SUBJECT: NORTH ANNA POWER STATION, UNITS 1 AND 2 - STAFF ASSESSMENT OF INFORMATION PROVIDED PURSUANT TO TITLE 10 OF THE *CODE OF FEDERAL REGULATIONS* PART 50, SECTION 50.54(f), SEISMIC HAZARD REEVALUATIONS RELATING TO RECOMMENDATION 2.1 OF THE NEAR-TERM TASK FORCE REVIEW OF INSIGHTS FROM THE FUKUSHIMA DAI-ICHI ACCIDENT (TAC NOS. MF3797 AND MF3798)

STAFF ASSESSMENT BY THE OFFICE OF NUCLEAR REACTOR REGULATION

RELATED TO SEISMIC HAZARD AND SCREENING REPORT

NORTH ANNA POWER STATION, UNITS 1 AND 2

Figure 3.3-1: Plot of Staff's and Licensee's Base Case Shear-Wave Velocity Profile for the NAPS site

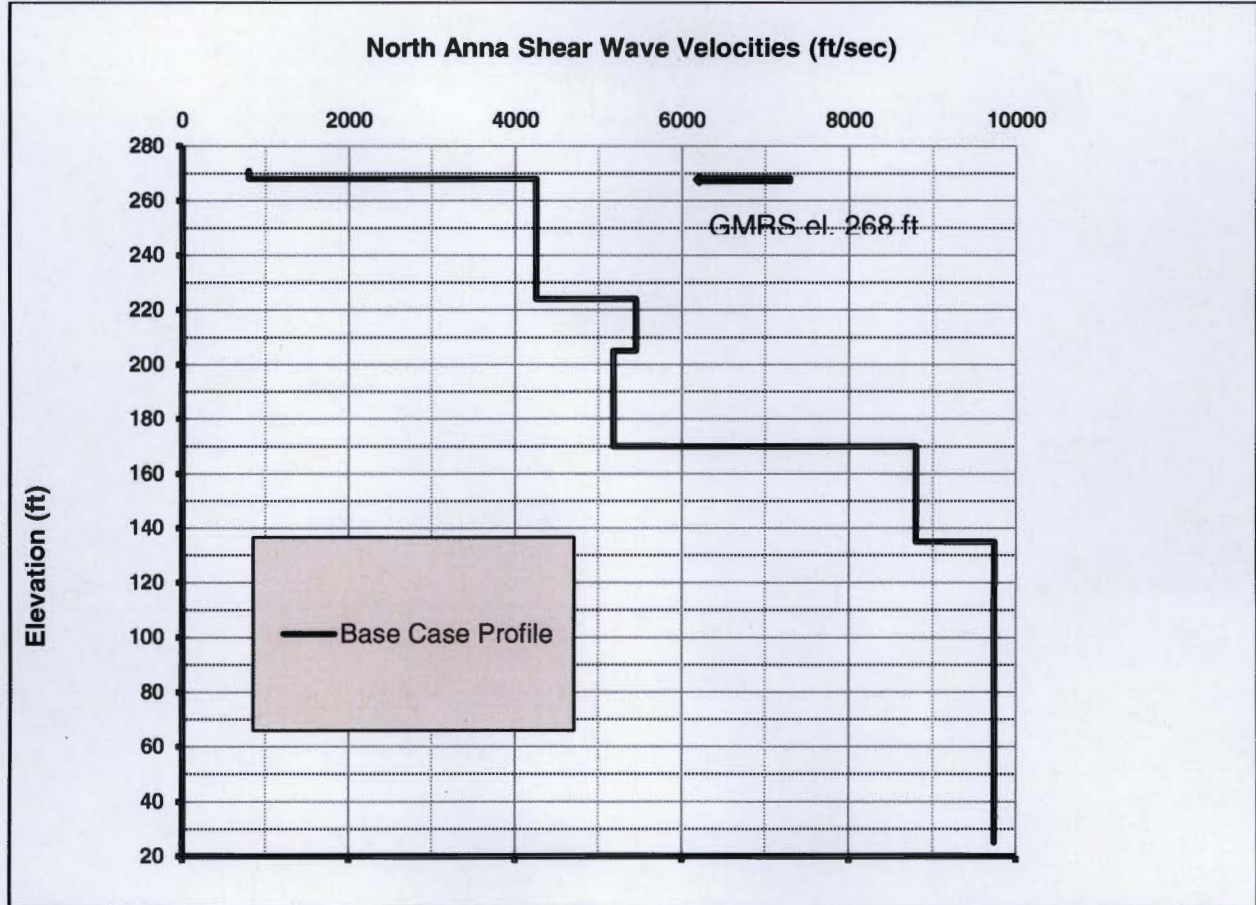
To confirm the licensee's site response analysis, the staff performed site response calculations for the NAPS site. For the confirmatory analysis, the staff calculated the site response using most of the licensee's inputs because the site is well characterized and the licensee used information based on actual detailed site investigations. For its site response calculations, the staff employed the RVT approach and developed input ground motions in accordance with Appendix B of the SPID. Figure 3.3-1 of this assessment shows the best case shear wave velocity profile used by both the licensee and staff for the site response analysis.

Figure 3.3-2 Plot Comparing the Staff's and the License's Median Amplification Functions and Uncertainties for two input loading levels for the NAPS site

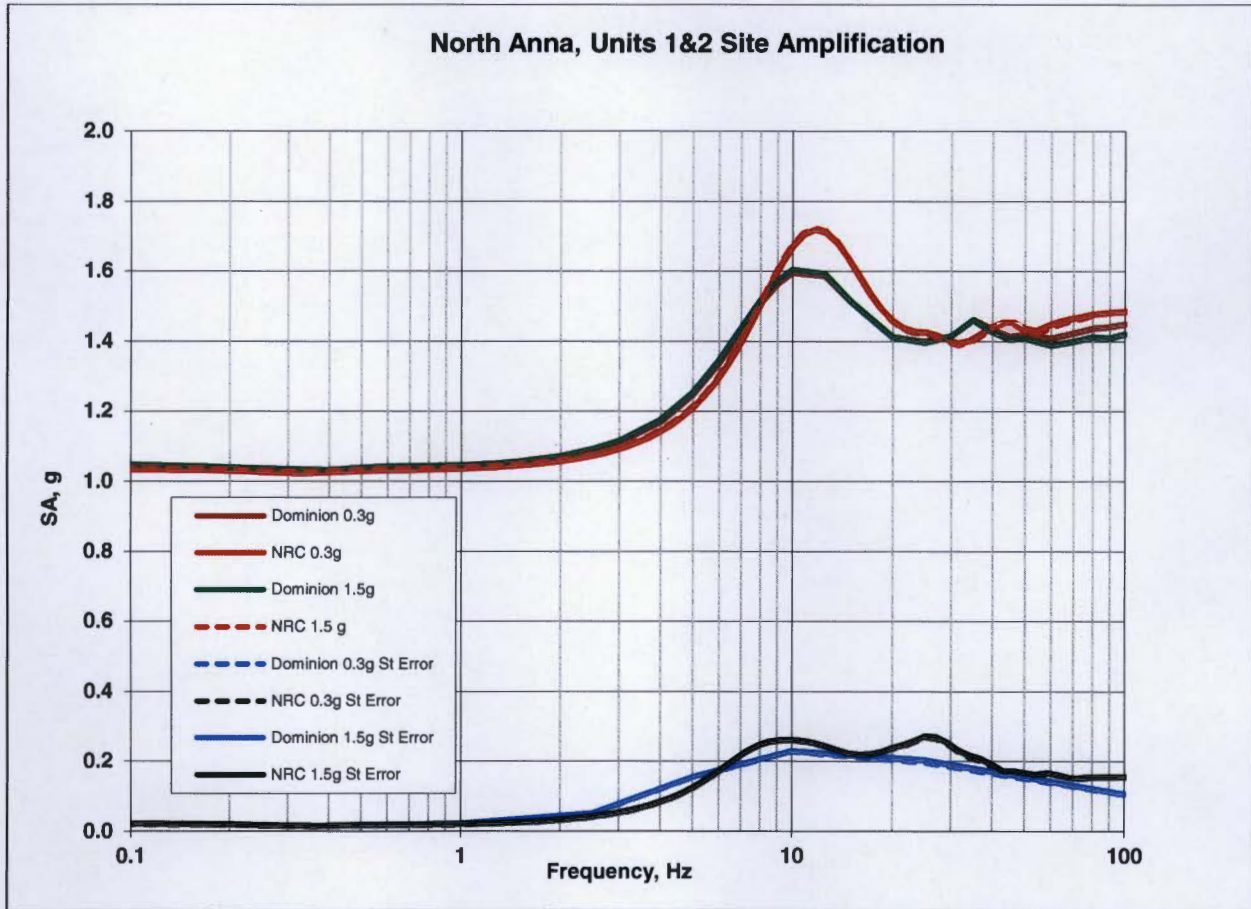
Figure 3.3-2 shows a comparison of the staff's and licensee's median site amplification factors and uncertainties (± 1 standard deviation) for two of the eleven input loading levels. The staff's median site amplification factors are very similar to the licensee's with values close to 1 and a modest peak of about 1.7 at 10 Hz. In addition, the staff's calculated amplification factor uncertainties are very similar to those of the licensee's.

Figure 3.3-3 Plot Comparing the Staff's and the Licensee's Mean Control Point Hazard Curves at a Variety of Frequencies for the NAPS site

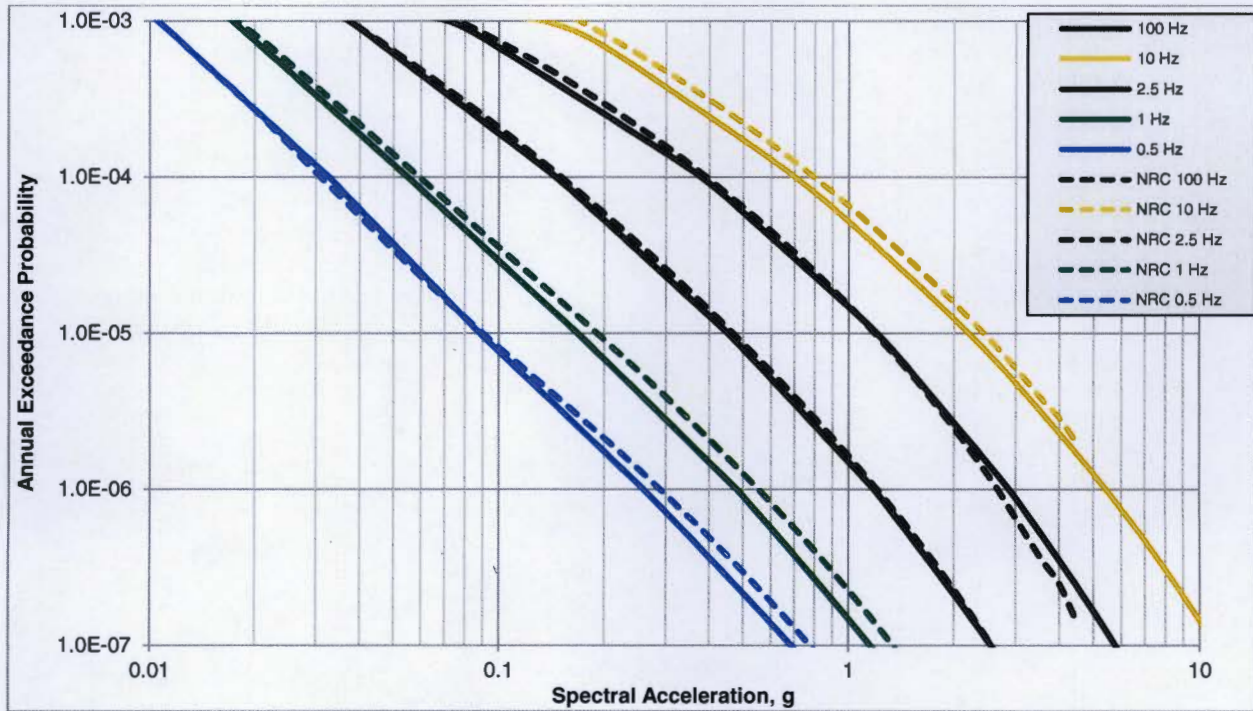
Overall, the licensee's approach to modeling the subsurface rock properties and their uncertainty results in very similar site amplification factors relative to the staff's results. Consequently, as shown in Figure 3.3-3 of this assessment, the control point seismic hazard curves developed by the licensee and staff are also very similar. Appendix B of the SPID provides guidance for performing site response analyses, including capturing the uncertainty for sites with less subsurface data; however, abundant data exists for the NAPS site. As such, alternative approaches in performing site response analyses, including the modeling of uncertainty, are acceptable for the 50.54(f) response.

Figure 3.4-1 Comparison of the Staff's GMRS, Licensee's GMRS, and the NAPS SSE

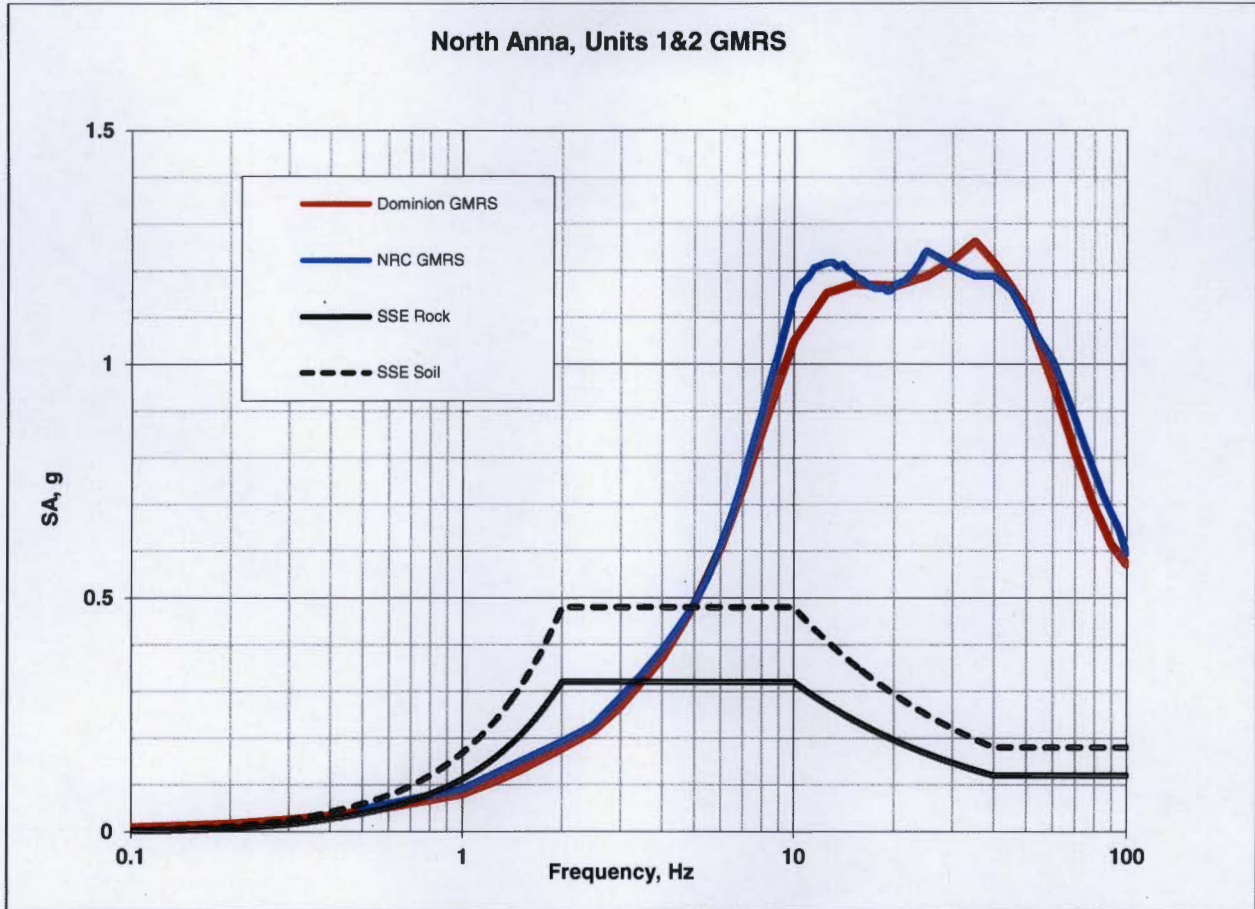
The staff independently calculated the 10^{-4} and 10^{-5} UHRS using the results of its confirmatory PSHA and site response analyses, as described in Sections 3.2 and 3.3 of this staff assessment, respectively. Figure 3.4-1 of this assessment shows a comparison of the GMRS determined by the licensee to that determined by the staff.

As shown in Figure 3.4-1 of this assessment, the licensee's GMRS is very similar to the staff's confirmatory GMRS. The staff concludes that the small differences between the two GMRS are acceptable for this application because the licensee followed the guidance provided in the SPID with respect to both the PSHA and site response analysis for the NAPS site.
